**PUBLIC MEETING
TOWN OF HUDSON, NH
APRIL 13, 2016**

Y151 Transmission Line Rebuild Project ZBA Input Only

Staff Report

Hudson T-Bones Patio Project Conceptual Plan

DWG. NO. **1**
 OF 1

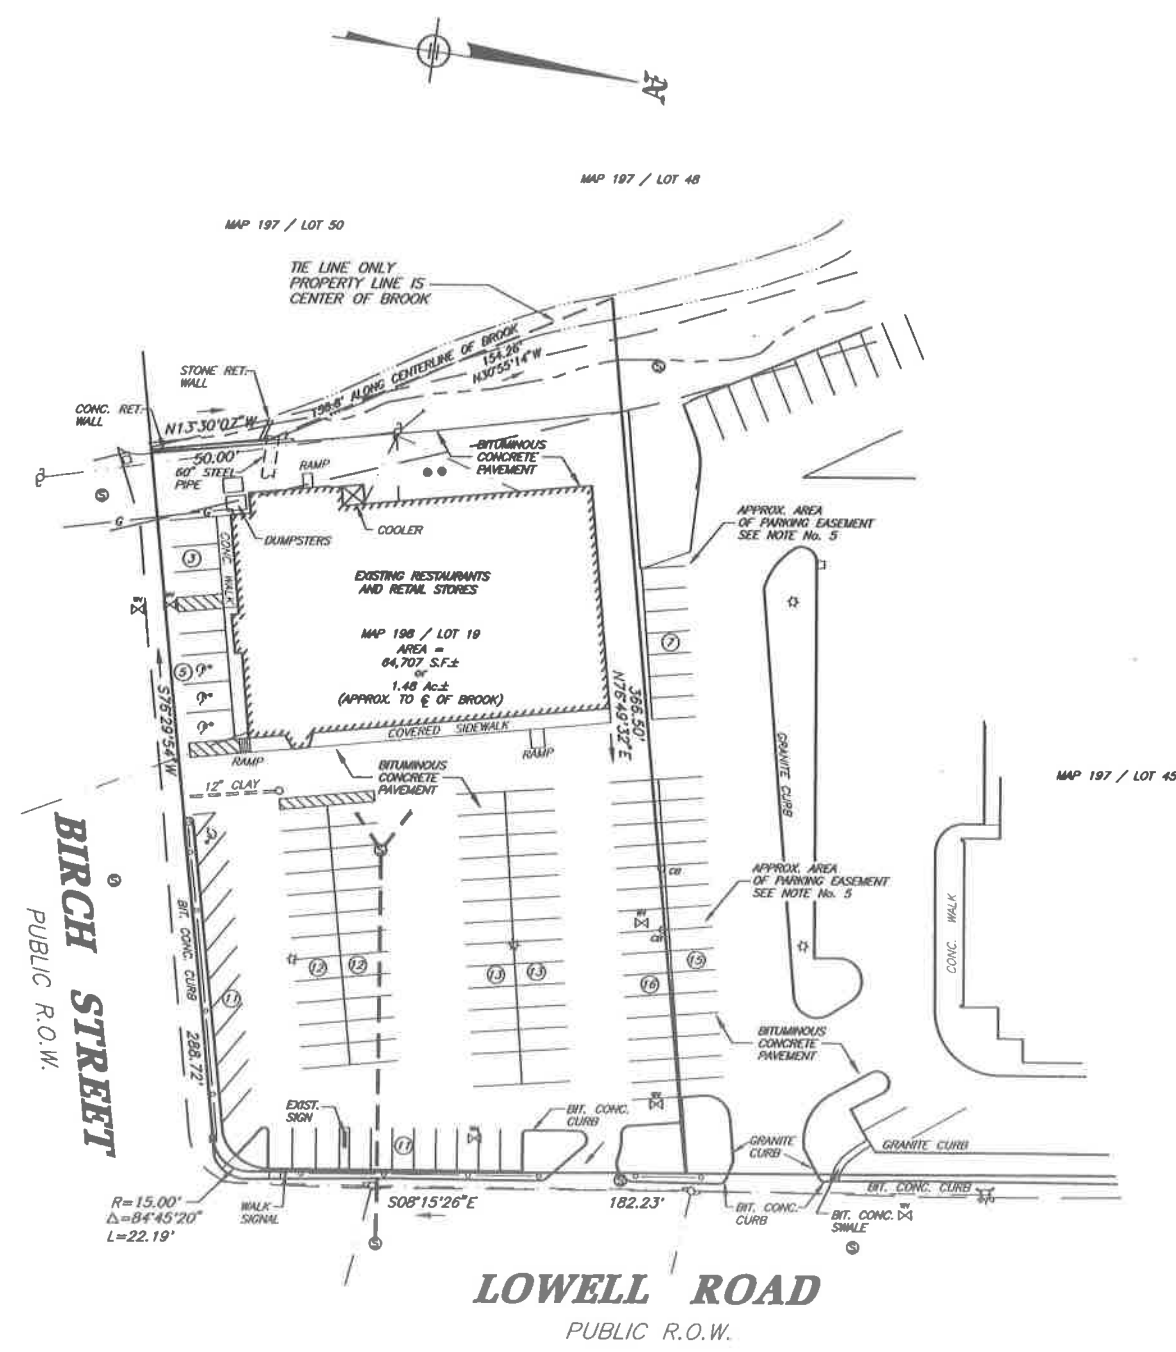
Note: parking for the patio also involves: (i) the elimination of 6 existing parking spaces, which includes 2 HP spaces, and (ii) Lot 145 already has an 18 space parking deficiency (see Note 10 of Dwg. No 1 of attached Maynard & Paquette Plan, dated 28 MAR 2003, which cites said deficiency on the subject Lot 145-1). Please note further, however, that a recorded Cross-Parking Easement exists for Lots 145-1 & 145, which is the abutting Citizens Bank/Rite Aide Pharmacy lot, and both lots are owned by the same party. In this regard, said Cross-Parking Easement, technically, provides for the increased deficiency of onsite parking, caused by the proposed patio. See Note 13 on the attached Maynard Plan, which cites an excess of 22 parking spaces, relative to the existing parking requirements for the multiple uses operating within both of the subject lots. That is, the proposed patio requires an increase of 16 additional parking spaces for both lots (i.e., 6 existing spaces will be eliminated with the patio and 10 new spaces are required, relative to its sqft. - 750 sf), and in accordance with said Note 13, there are 22 excess spaces for the 2 subject lots, ultimately resulting in 3 extra parking spaces.

DRAWING TITLE: CONCEPTUAL LAYOUT PLAN SHEET No. C-1

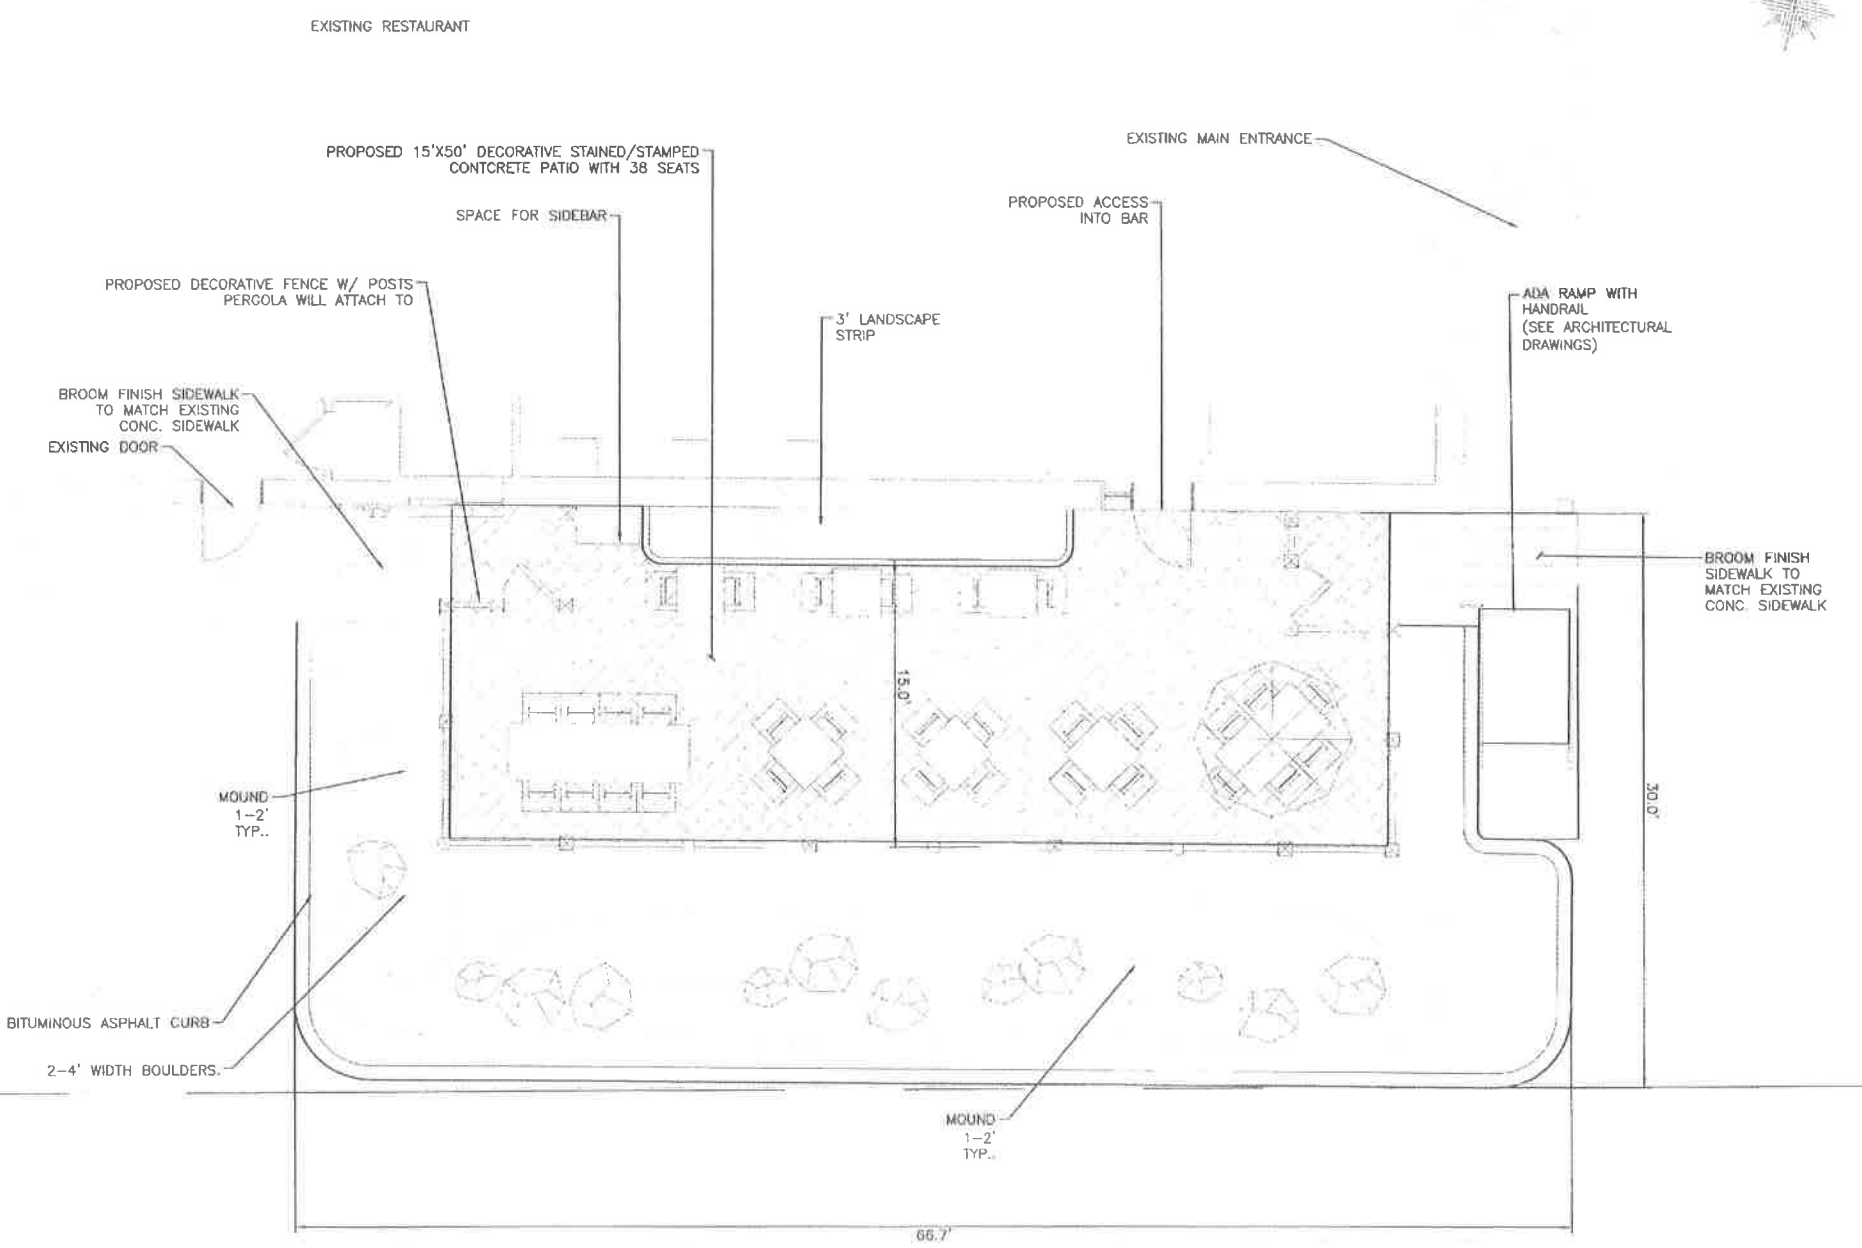
One other issue concerning the patio is providing a sufficient barrier to protect patrons from any nearby travelling vehicles. Sheet C1 of the attached Plan set, depicts a landscaped mound, surrounded by bituminous concrete curbing and a railing around the patio. The board may want to consider adding to

this design RC bollards at the easterly end of the patio (closest to Lowell Rd.), relative to enhancing safety concerns of traffic heading westbound on Birch St. and into T-Bones parking lot.
